**SERVICE BULLETIN**

<sub>N°</sub> 139-581

**DATE:** March 25, 2021

**ATA 21 - VENTILATION INSULATION IMPROVEMENT**

Figure 2

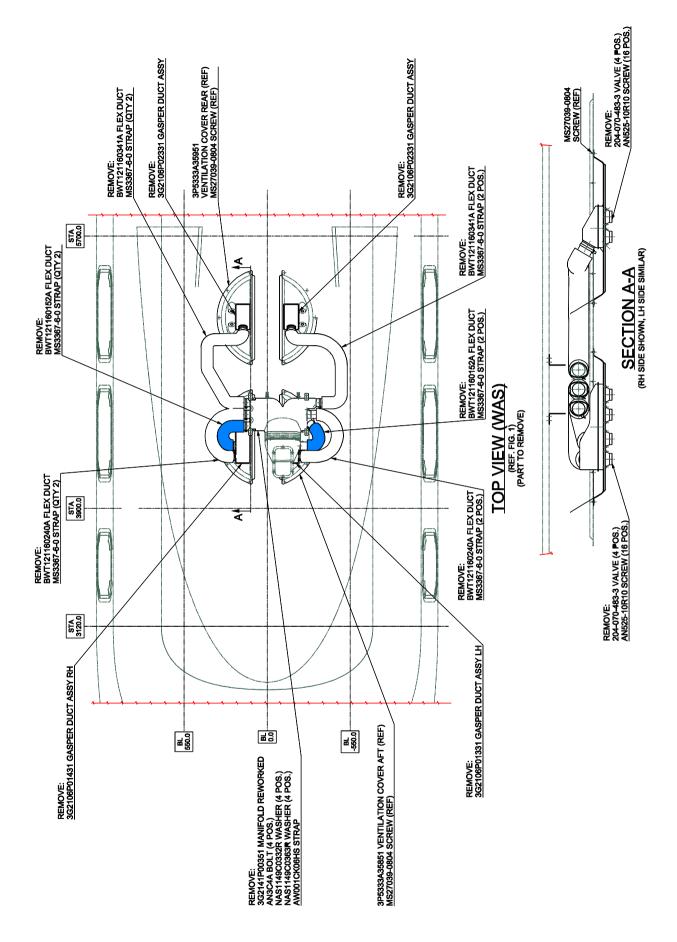
- 2.3 With reference to Figure 3 Detail E, remove the n°2 water drain lines and keep the existing fasteners for the next reinstallation.
  - 2.4 With reference to Figure 2, RH side, remove manifold P/N 3G2141P00351, strap P/N AW001CK06CH, n°4 bolts P/N AN3C4A, n°4 washers P/N NAS1149C0332R, n°4 washers P/N NAS1149C0363R. Keep the hardware for the next reinstallation.

2.5 With reference to Figure 2, remove flex duct P/N BWT121160240A, n°2 strap P/N MS3367-6-0.

- 2.6 With reference to Figure 2, remove flex duct P/N BWT121160152A, n°2 strap P/N MS3367-6-0.
- 2.7 With reference to Figure 2, remove flex duct P/N BWT121160341A, n°2 strap P/N MS3367-6-0.

- 2.8 With reference to Figure 2 Section A-A, remove n°2 valves P/N 204-070-483-3, n°8 screws P/N AN525-10R10. Keep the hardware for the next reinstallation.

- 2.9 With reference to Figure 2, remove the n°1 ventilation rear cover P/N 5333A35951, n°5 screws MS27039-0804. Keep the n°1 cover and the hardware for the next reinstallation.

- 2.10 With reference to Figure 2, remove gasper duct assy P/N 3G21106P02331.
- 2.11 With reference to Figure 2 Section A-A, remove n°4 valves P/N 204-070-483-3, n°16 screws P/N AN525-10R10. Keep the hardware for the next reinstallation.

- 2.12 With reference to Figure 2, remove the n°1 ventilation rear cover P/N 5333A35851, n°5 screws MS27039-0804. Keep the n°1 cover and the hardware for the next reinstallation.

- 2.13 With reference to Figure 2, remove gasper duct assy P/N 3G21106P01431.

2.14 With reference to Figure 2, RH side, remove flex duct P/N BWT121160240A, n°2 strap P/N MS3367-6-0.

- 2.15 With reference to Figure 2, remove flex duct P/N BWT121160152A, n°2 strap P/N MS3367-6-0.
- 2.16 With reference to Figure 2, remove flex duct P/N BWT121160341A, n°2 strap P/N MS3367-6-0.
- 2.17 With reference to Figure 2 Section A-A, remove n°2 valves P/N 204-070-483-3, n°8 screws P/N AN525-10R10. Keep the hardware for the next reinstallation.

- 2.18 With reference to Figure 2, remove the n°1 ventilation rear cover P/N 5333A35951, n°5 screws MS27039-0804. Keep the n°1 cover and the hardware for the next reinstallation.

- 2.19 With reference to Figure 2, remove gasper duct assy P/N 3G21106P02331.
- 2.20 With reference to Figure 2 Section A-A, remove n°4 valves P/N 204-070-483-3, n°16 screws P/N AN525-10R10. Keep the hardware for the next reinstallation.

- 2.21 With reference to Figure 2, remove the n°1 ventilation rear cover P/N 5333A35851, n°5 screws MS27039-0804. Keep the n°1 cover and the hardware for the next reinstallation.

- 2.22 With reference to Figure 2, remove gasper duct assy P/N 3G21106P01331.
- 2.23 With reference to Figure 3 and Figure 4 Detail F, install manifold P/N AA0725A-00 using existing hardware and one strap P/N AW001CK06HS.

Figure 3

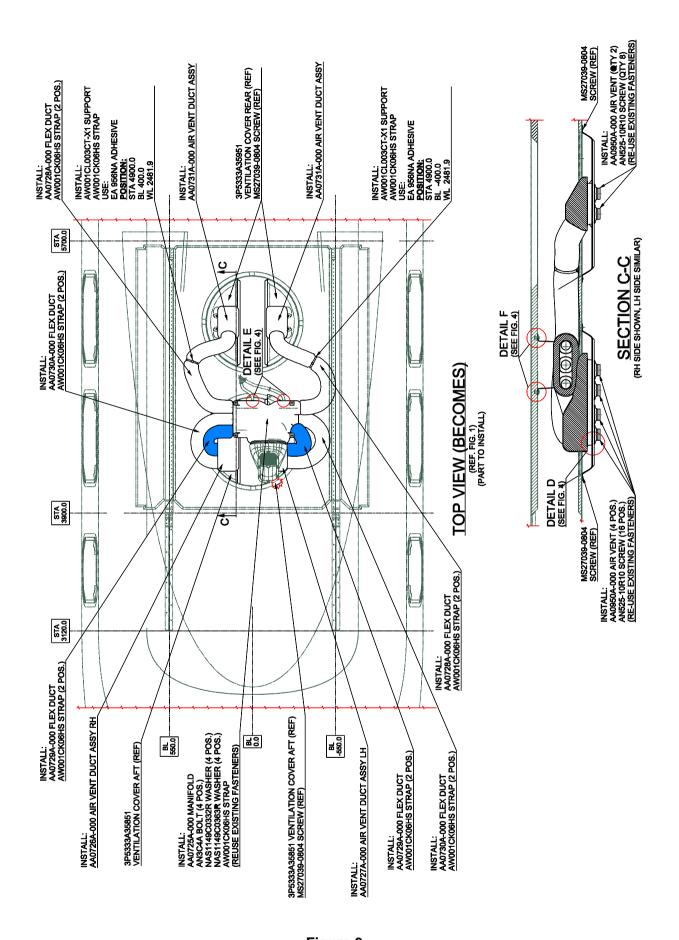
- 2.24 With reference to Figure 3 Detail E, reinstall the n°2 water drain lines using existing fasteners.

- 2.25 With reference to Figure 3 on RH side, install flex duct P/NAA00729A-000 using N°2 strap P/N AW001CK06HS.
- 2.26 With reference to Figure 3 on RH side, install flex duct P/NAA00730A-000 using N°2 strap P/N AW001CK06HS.

- 2.27 With reference to Figure 3 Section C-C, install n°1 air vent duct assy RH P/N AA0726A-000, n°4 air vent P/N AA0950A-000 using existing screws.
- 2.28 Reinstall ventilation cover AFT P/N 3P5333A35851 using existing hardware.

- 2.29 With reference to Figure n°3 install on indicated position n°1 support P/N AW001CL003CT-X1 using adhesive P/N EA 956NA.
- 2.30 With reference to Figure 3 on RH side, install flex duct P/NAA00728A-000 using N°3 strap P/N AW001CK06HS.

- 2.31 With reference to Figure 3 install air vent duct assy P/N AA0731A-000, n°2 air vent AA0950A-000 using existing screws.
- 2.32 Reinstall ventilation cover rear P/N 3P5333A35951 using existing hardware.

- 2.33 With reference to Figure 3 on LH side, install flex duct P/NAA00729A-000 using N°2 strap P/N AW001CK06HS.
- 2.34 With reference to Figure 3 on LH side, install flex duct P/NAA00730A-000 using N°2 strap P/N AW001CK06HS.

- 2.35 With reference to Figure 3 Section C-C, install n°1 air vent duct assy LH P/N AA0727A-000, n°4 air vent P/N AA0950A-000 using existing screws.
- 2.36 Reinstall ventilation cover AFT P/N 3P5333A35851 using existing hardware.

- 2.37 With reference to Figure n°3 install on indicated position n°1 support P/N AW001CL003CT-X1 using adhesive P/N EA 956NA.
- 2.38 With reference to Figure 3 on LH side, install flex duct P/NAA00728A-000 using N°3 strap P/N AW001CK06HS.

- 2.39 With reference to Figure 3 install air vent duct assy P/N AA0731A-000, n°2 air vent AA0950A-000 using existing screws.
- 2.40 Reinstall ventilation cover rear P/N 3P5334A35951 using existing hardware.

Figure 4

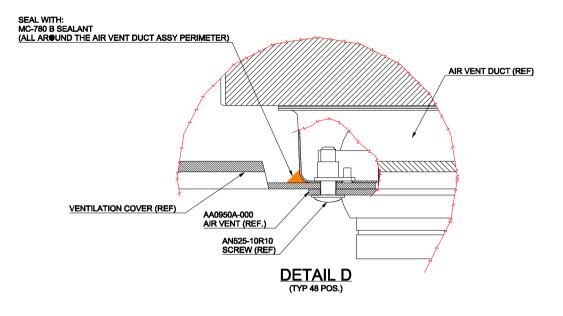
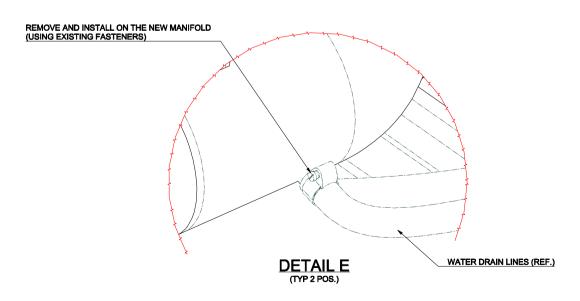
Seal all around the air vent duct assy perimeter with a fillet of sealant MC-780 B, as shown on Figure 4 Detail D.

Figure 5

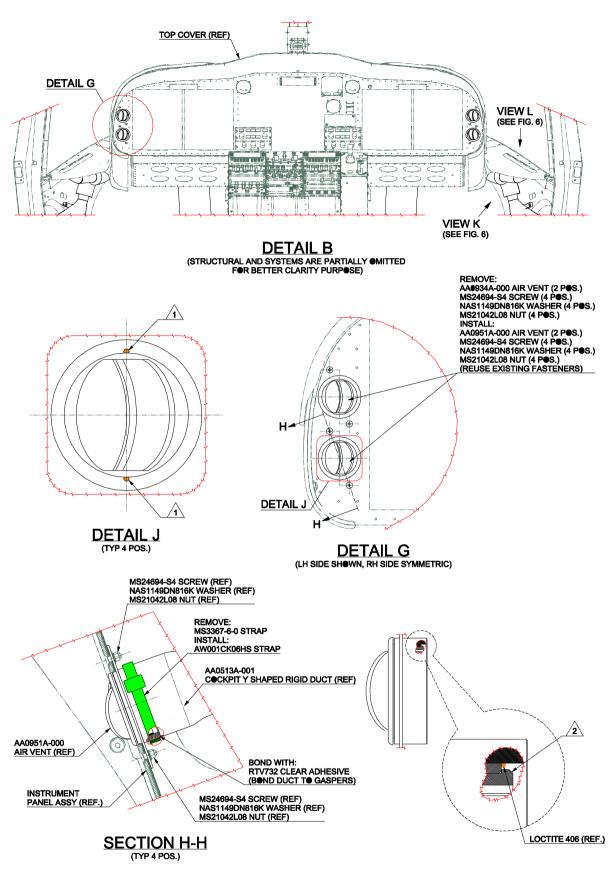
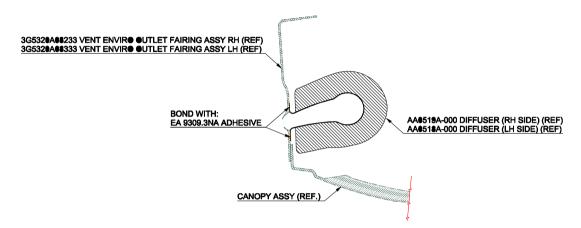
- 2.45 In accordance to AMP DM 39-B-31-11-02-00A-520A-A and with reference to Figure 5, remove the top cover to get access at n°4 air vents.
- 2.46 In accordance to applicable maintenance steps of AMP DM 39-A-21-20-06-00A-520A-A and with reference Figure 5 Detail G, remove top left air vent P/N AA0934A-000, strap P/N MS33677-6-0, n°2 screws P/N MS24694-54, n°2 washer P/N NAS1149DN816K, n°2 nuts P/N MS21042L08. Keep the hardware for the next reinstallation.

- 2.47 In accordance to applicable maintenance steps of AMP DM 39-A-21-20-06-00A-720A-A install top left air vent P/N AA0951A-000 using existing hardware. After the air vent assembly, apply 2 drops of Loctite 406 on the ventilation outlet in the 2 positions as shown on Figure 5 Detail J.

- 2.48 With reference to Figure 5 Section H-H, install cockpit Y shaped rigid duct on top left air vent P/N AA0951A-000 using adhesive RTV732 and strap P/N AW001CK06HS.

- 2.49 In accordance to applicable maintenance steps of AMP DM 39-A-21-20-07-00A-520A-A and with reference Figure 5 Detail G, remove bottom left air vent P/N AA0934A-000, strap P/N MS33677-6-0, n°2 screws P/N MS24694-54, n°2 washer P/N NAS1149DN816K, n°2 nuts

- P/N MS21042L08. Keep the hardware for the next reinstallation.
- 2.50 In accordance to applicable maintenance steps of AMP DM 39-A-21-20-07-00A-720A-A install bottom left air vent P/N AA0951A-000 using existing hardware. After the air vent assembly, apply 2 drops of Loctite 406 on the ventilation outlet in the 2 positions as shown on Figure 5 Detail J.

- 2.51 With reference to Figure 5 Section H-H, install cockpit Y shaped rigid duct on left bottom air vent P/N AA0951A-000 using adhesive RTV732 and strap P/N AW001CK06HS.

1 - AFTER THE AIR VENT ASSEMBLY, APPLY 2 DROPS OF LOCTITE 486 ON THE VENTILATION OUTLET IN THE 2 POSITIONS SHOWN ON "DETAIL J".

2 - During the application of loctite 406 be careful to not apply the seal on this part.

Figure 6

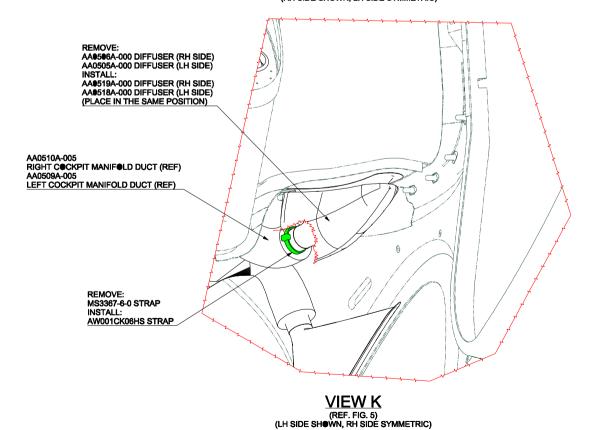
- 2.41 In accordance to AMP DM 39-A-71-11-07-00A-720A-A install forward sliding fairing 473AL.
- 2.42 With reference to Figure 6 View K, remove diffuser P/N AA0506A-000 (RH side), one strap P/N MS3367-6-0.

- 2.43 With reference to Figure 6 View K, install diffuser P/N AA0519A-000 (RH side), one strap P/N AW001CK06HS.
- 2.44 With reference to Figure 5 View L, Figure 6 Section M-M, bond diffuser P/N AA0519A-000 on ventilation environmental outlet fairing assy RH P/N 3G5320A082333 using adhesive EA9303.3NA.
